Update on 802.1 Maintenance Request 193

Rodney Cummings
National Instruments

802.1 Maintenance Request 193

Insert a new Figure 12-6, titled "Points in time for scheduled traffic":

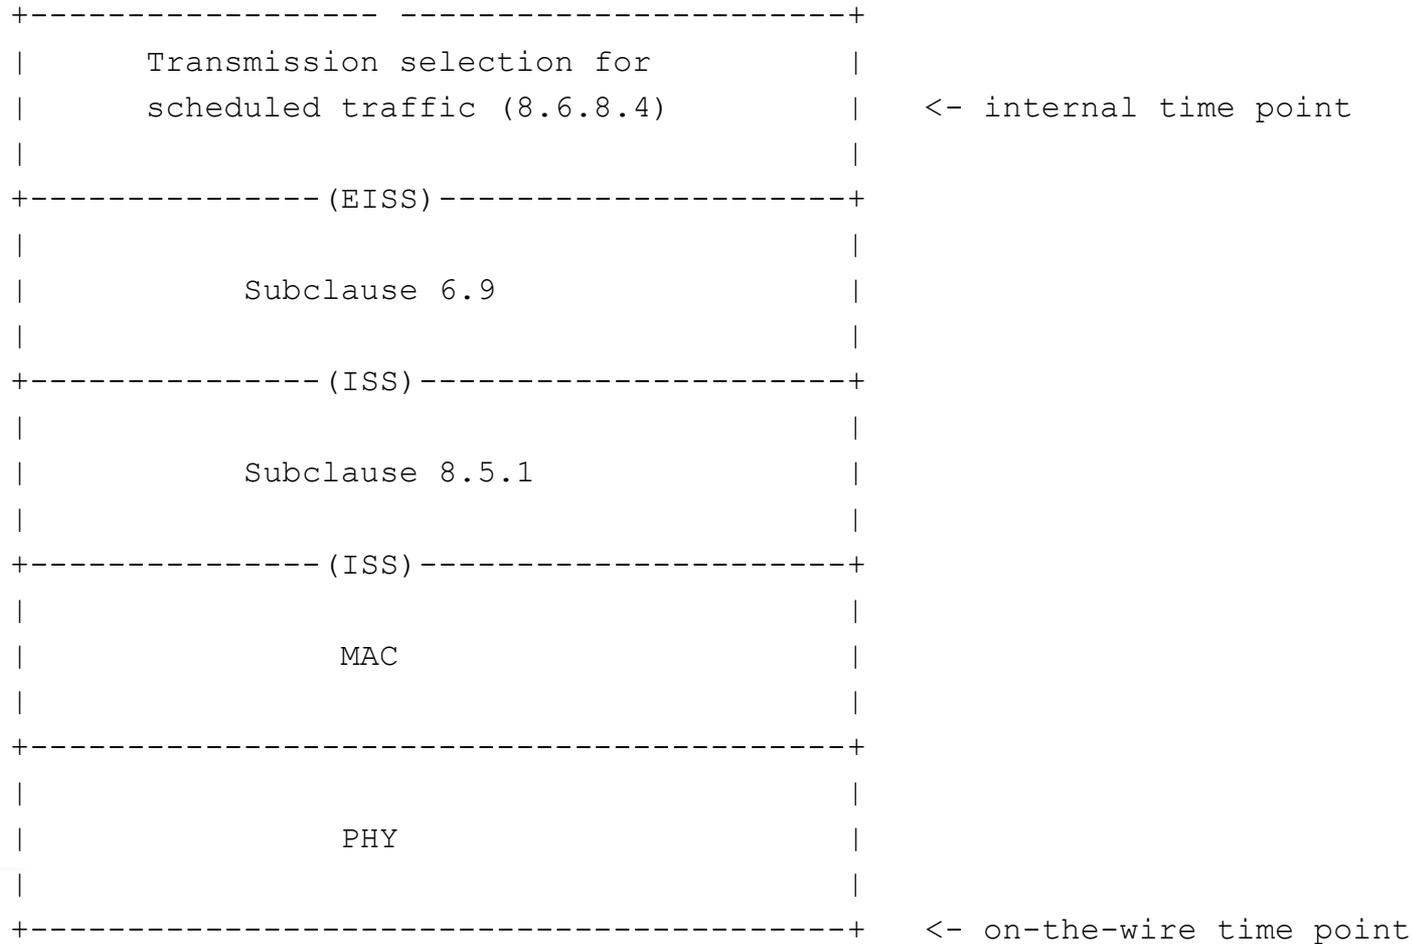
Figure 12-6 shows two points in time for scheduled traffic. The time of gate open/close described in subclause 8.6.8.4 is used for transmission selection, and that point in time exists internal to the Bridge (i.e. above MAC and PHY). A delay exists between this internal time point and the time of transmit on-the-wire. For example, if transition of a gate from closed to open immediately results in selection of a frame for transmission, there will be a delay from that internal time of transmission selection to the start of the frame on-the-wire. The internal time ~~point~~ of transmission selection will have variance and will be bounded (min/max), and the delay to the on-the-wire time point will also have variance.
